Mountain Valley Pipeline Project

Docket No. CP16-10-000

March 2, 2017

Re: Comments on the Federal Energy Regulatory Commission (FERC) Draft Environmental Impact Statement (DEIS) for the Proposed Mountain Valley Project by the Mountain Valley Pipeline Company, LLC and proposed Equitrans Expansion Project by the Equitrans LP; FERC No. CP16-10-000, CP16-13-000; West Virginia and Virginia

Attachment 1

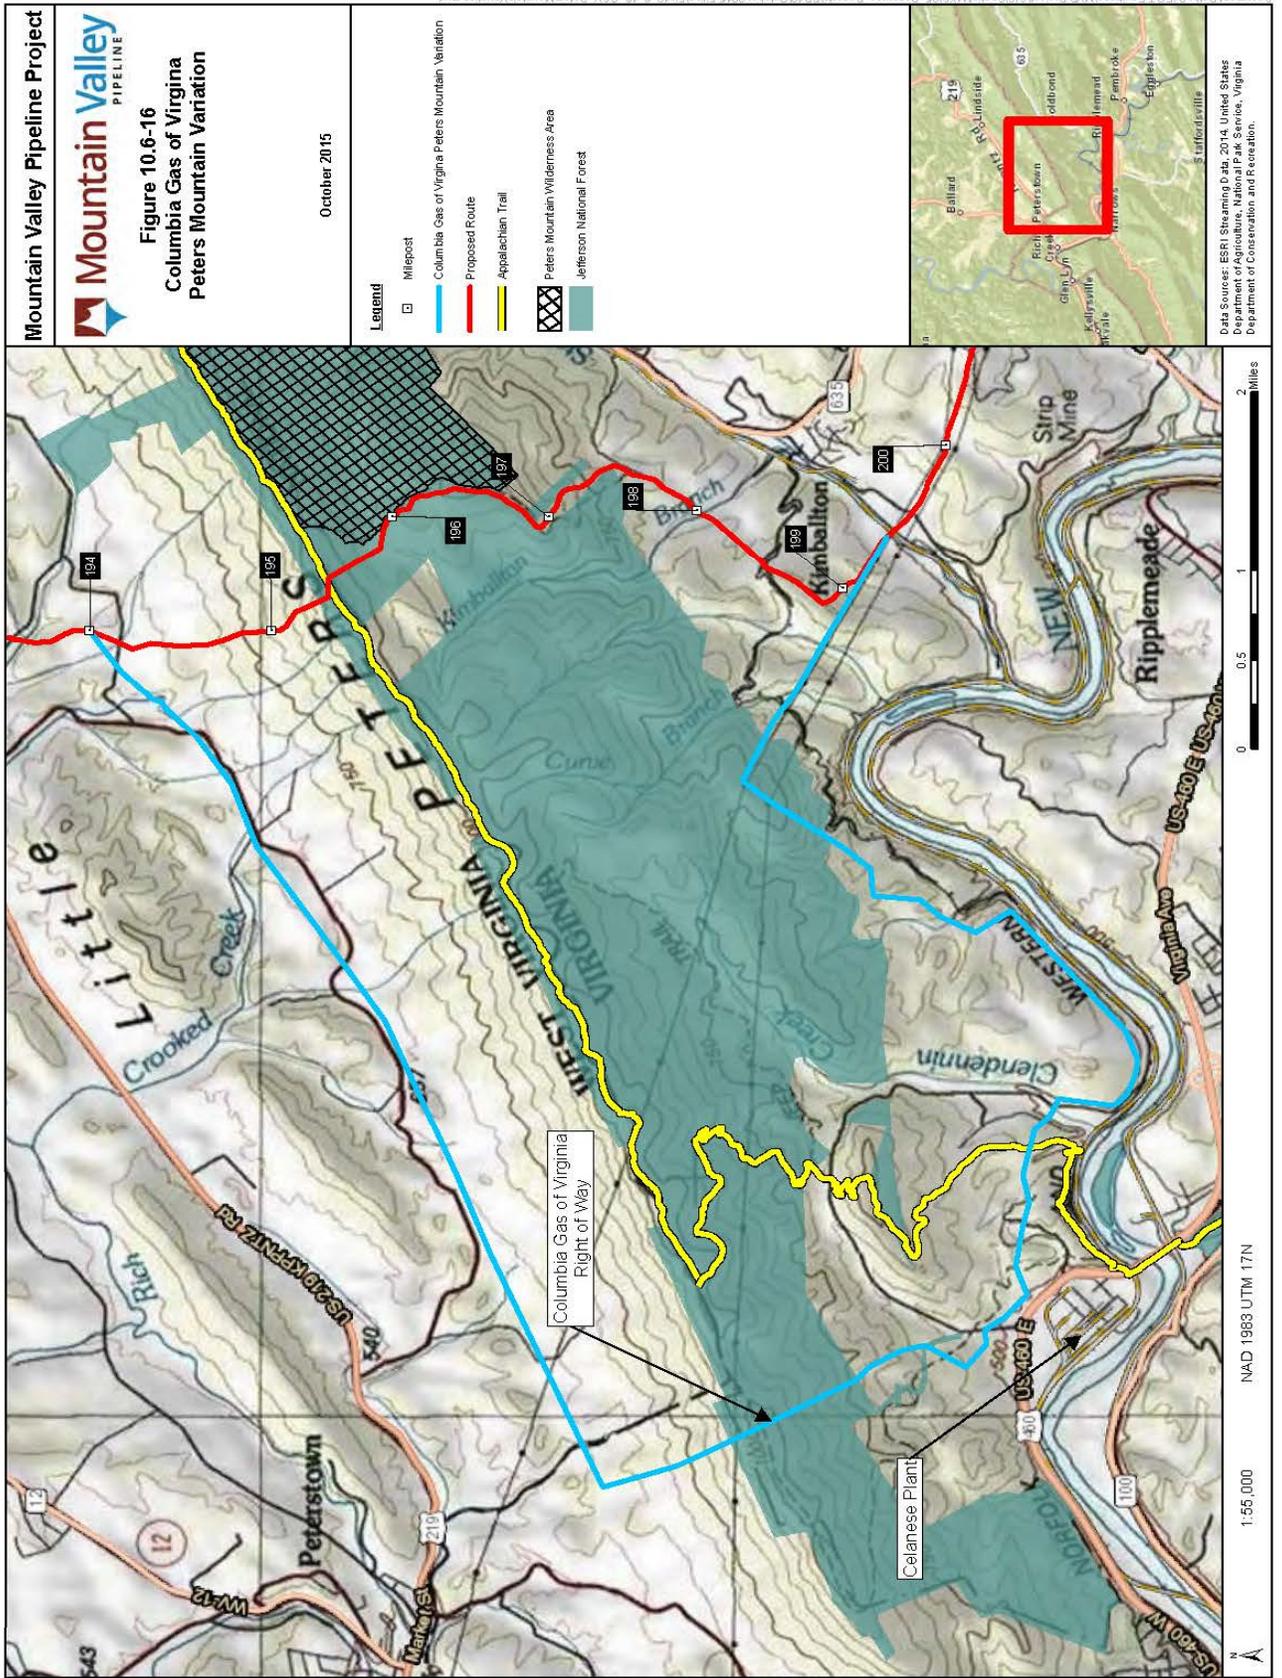
NPS Comment No. 7: Columbia Gas of Virginia (CVG) Peters Mountain Variation: The CVG Peters Mountain Variation would cross the Trail in Craig County, VA. This alternative was proposed as an alternative crossing of the Jefferson National Forest and the ANST to increase the amount of collocation along an existing pipeline right-of-way. The conclusion drawn in the DEIS that this alternative does not offer a significant environmental advantage compared to the proposed route. The NPS identified substantive issues with the analysis and recommends this alternative be re-evaluated.

NPS Comment No. 8: CVG Peters Mountain Variation: The route of the ANST on the maps showing the proposed and alternative crossing of the ANST is inaccurate.

NPS Comment No. 9: CVG Peters Mountain Variation: A comparison of visual impacts on the ANST between these two routes is needed to inform impacts to the Trail as part of the alternative comparison.

NPS Comment No. 11: CVG Peters Mountain Variation and State Route 635-ANST Variation: The map provided on page 3-48 of these two alternatives [Figure 3.5.1-7] does not accurately reflect the current ANST route.

Mountain Valley Response No. 7: The CGV Peters Mountain Variation of the ANST is shown on the attached Figure 10.6-16 (Attachment 1). Mountain Valley developed the route of the CGV Peters Mountain Variation and the associated environmental analysis using the location of the ANST as depicted on Figure 10.6-16, and the analysis included in Section 3.5.1.5 and Table 3.5.1-5 of the DEIS is based on the location of the ANST and is therefore accurate. Of note, the variation crosses the location of the ANST only once.

Mountain Valley Response No. 8: Prior to the recent easement agreement between the USFS and Celanese that resulted in relocation of the ANST to the east of the CGV pipeline. The current CGV Peters Mountain Variation of the ANST is shown on the attached Figure 10.6-16, labeled as Attachment 1.

Mountain Valley Response No. 9: Please see Response No. 8 and Attachment 1. The map contains a visual and cultural comparison of visual impacts on the ANST between the two routes.

Mountain Valley Response No. 11: Please see Attachment 1 for an updated map depicting the alternatives.
